APPLICATION NO.	FILING DATE	FIRST NAMED INVENTOR	ATTORNEY DOCKET NO.	CONFIRMATION NO.
10/736,947	12/16/2003	Richard C. Chu	POU920030165US1	5523
46369 7	590 08/09/2005	EXAMINER		
HESLIN ROTHENBERG FARLEY & MESITI P.C.			FITZGERALD, JOHN P	
	5 COLUMBIA CIRCLE ALBANY, NY 12203		ART UNIT	PAPER NUMBER
			2856	
			DATE MAILED: 08/09/2005

Application No.	Applicant(s)				
	10/736,947	CHU ET AL.				
Office Action Summary	Examiner	Art Unit				
	John P. Fitzgerald	2856				
The MAILING DATE of this communication app	_					
Period for Reply						
A SHORTENED STATUTORY PERIOD FOR REPLY THE MAILING DATE OF THIS COMMUNICATION. - Extensions of time may be available under the provisions of 37 CFR 1.13 after SIX (6) MONTHS from the mailing date of this communication. - If the period for reply specified above is less than thirty (30) days, a reply - If NO period for reply is specified above, the maximum statutory period w Failure to reply within the set or extended period for reply will, by statute, Any reply received by the Office later than three months after the mailing earned patent term adjustment. See 37 CFR 1.704(b).	6(a). In no event, however, may a reply be tim within the statutory minimum o

Fig. 16. Now schematic of a typical IBM contant distribution unit (CDU).

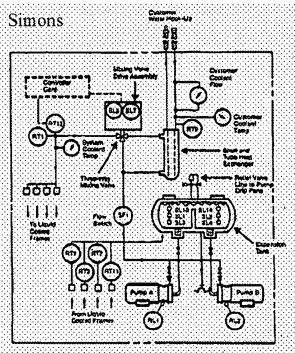
- 4. The text of those sections of Title 35, U.S. Code not included in this action can be found in a prior Office action.
- 5. Claims 1-3 and 7-11 are rejected under 35 U.S.C. § 103(a) as being unpatentable over Applicant's disclosed Prior Art document "The Evolution of IBM High Performance Cooling Technology" by Simons (hereinafter Simons), US 5,245,869 to Clarke et al. (hereinafter Clarke) and US 5,323,847 to Koizumi et al. (hereinafter Koizumi). Simons discloses various apparatus/system and methods of monitoring coolant with a cooling systems, including closed loop (as recited in claims 3, 11, 22) water cooled systems (Section IV) (Fig. 16) which circulate and control the temperature of cooling water with a cooling distribution unit (CDU) including the elements of heat exchangers, temperature controllers, pumps, expansion tanks and water supply/return manifolds and the importance of all these elements to function properly and provide uninterrupted operation ensuring adequate cooling levels. Simons fails to disclose monitoring the coolant employing at least one pressure transducer to obtain multiple pressure measurements related to an amount of coolant within the expansion tank, determining a rate of volume change of coolant with the expansion tank employing the multiple pressure measurements (as recited in claims 1 and 9); the measurements being successive pressure measurements at known time intervals and related to the amount of coolant in the expansion

tank, thus determining the rate of volume change of the coolant with the expansion tank (as recited in claims 2 and 10); an wherein the pressure transducers are differential pressure transducers (as recited in claims 7, 8, 15 and 16). Clarke teaches a method of monitoring the amount (i.e. level) of liquid within a tank (Figs. 1-5) employing a differential pressure transducer (12) monitoring the amount of fluid above the transducer which is located at the bottom of the tank, making pressure measurements to determine an amount in the tank and a "loss rate" for leak detection (i.e. measurements over time periods, iterations) (Clarke: col. 5, lines 5-10 and col. 7, lines 30-33). It would have been obvious to one having ordinary skill in the art at the time the invention was made to employ pressure transducers to monitor the amount of coolant in the tank and all the recited method steps, as taught by Clarke, modifying the method of monitoring coolant within a cooling system disclosed by Simons, thus providing a high resolution and highly accurate sensor and system for monitoring the amount of coolant in the tank for safe, uninterrupted operation of the cooling system (Clarke: col. 1, lines 37-40).

Koizumi et al.

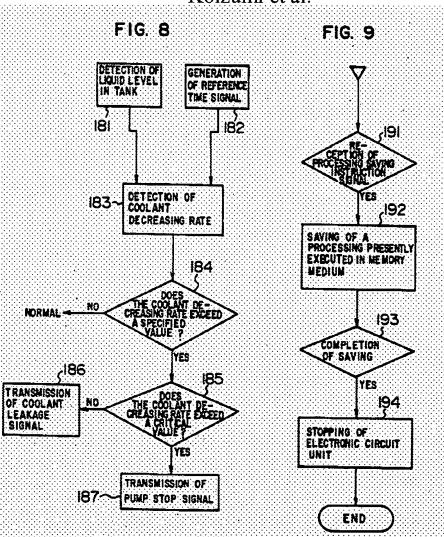
Simons and Clarke do not expressly disclose the employment of determining an immediacy of action to be taken to service the cooling system based on the rate of volume change (i.e. increasing as well as decreasing) within the expansion tank (as recited in claims 3, 11 and 19); and the employment of specific leak rate set points/thresholds that are exceeded or fall below particular levels of coolant within the coolant tank and the automatic determination and immediacy of action to be taken (i.e. service or shut-down) (as recited in claims 1 and 9). Koizumi teaches the monitoring of coolant levels for the cooling of an electronic apparatus (Figs. 1-14) wherein the amount (i.e. liquid/water/coolant level) is monitored at particular set points and thus actions (i.e. alarms/indicators) are actuated to inform an operator to take necessary

action such as stopping the operation of the electronic unit or inspecting the coolant (see Fig. 8 below) (Koizumi: cols. 8-11). It would have been obvious to one having ordinary skill in the art at the time the invention was made to employ limits/set-points to indicate immediacy of action to an operator and other obvious variants as recited in the instant claims, as taught by Koizumi, thus modifying the monitoring of coolant with a cooling system disclosed by Simons and Clarke, thus providing protection means alerting an operator to shut down the electronic unit associated with the cooling system.
